MOORE SCHOOL OF ELECTRICAL ENGINEERING
UNIVERSITY OF PENNSYLVANIA

MULT. CROSS SECTION, CONT'D.

Drawn by:	Checked by:	Approved by:	
MSM 10-23-45	YRS 12-15-45	AWS 12-15-45	PX-6-112(B)

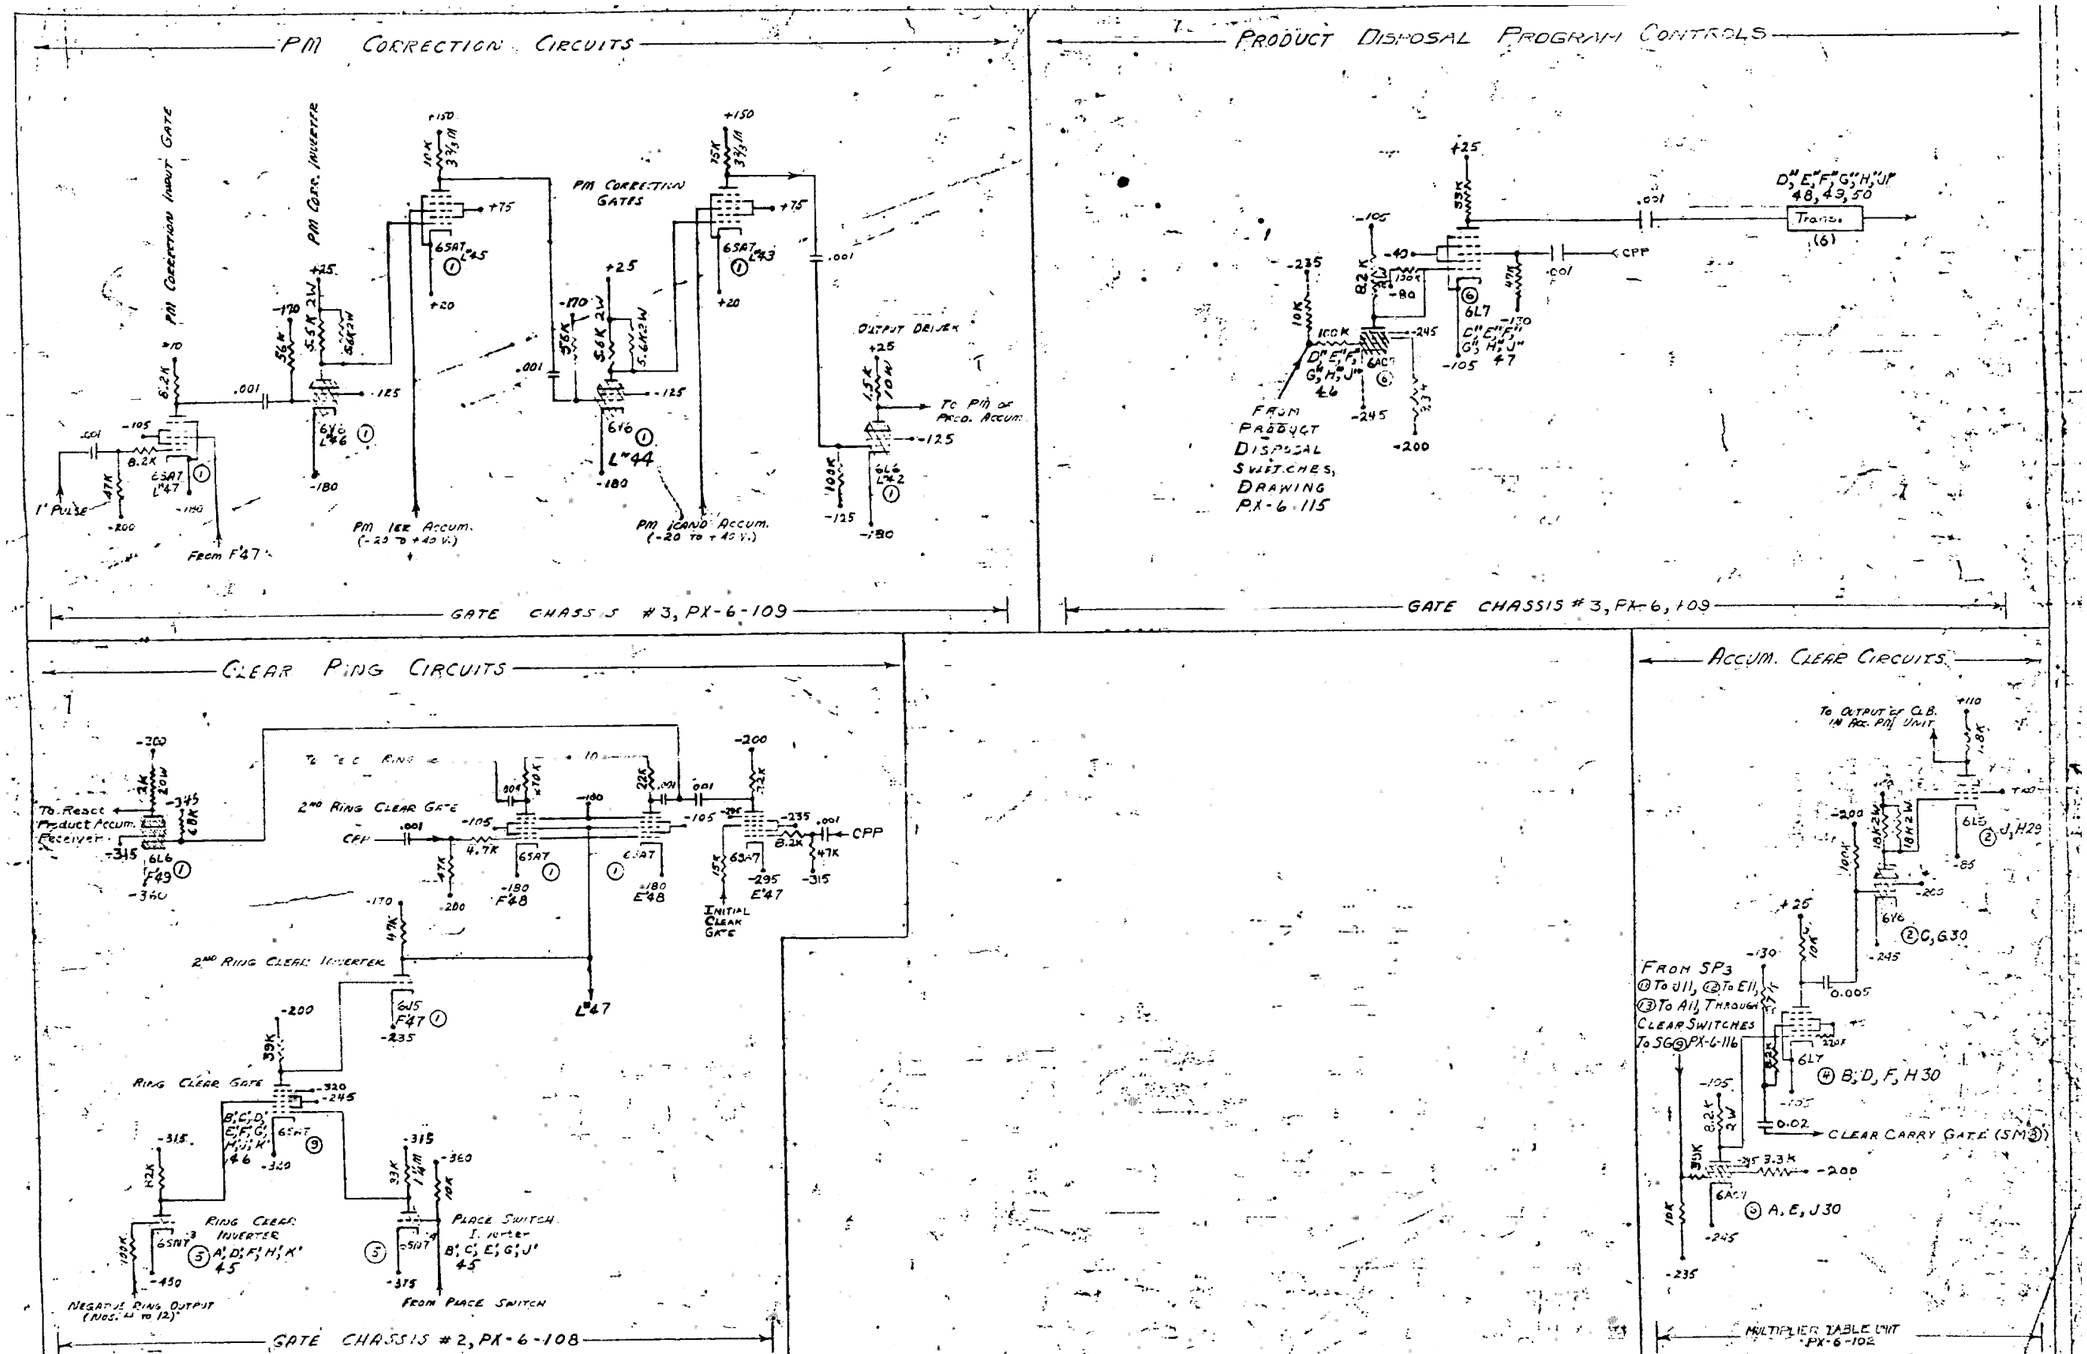
REVISIONS					
1	Revised 10K Grid Res. - Output Driver. June 9, 1945	2	Tube Location Numbers Added. GJT-45	3	Accumulator Clear Circuits Released from A1, L11, To A7N30 & H7N29. F.R.M. 8-2-45
4	Screens Changed on All Tubes 8-28-45. 8.2K Accum. 0.005 Changed to 0.02 on 46273 in Accumulator Clear Circuits. 100K Changed to 220.	5	Changed grid resistor on A, E, J30 from 100K to 39K.	6	Voltage to plus 100K To Grid of Output Driver PM Circuit was -170.
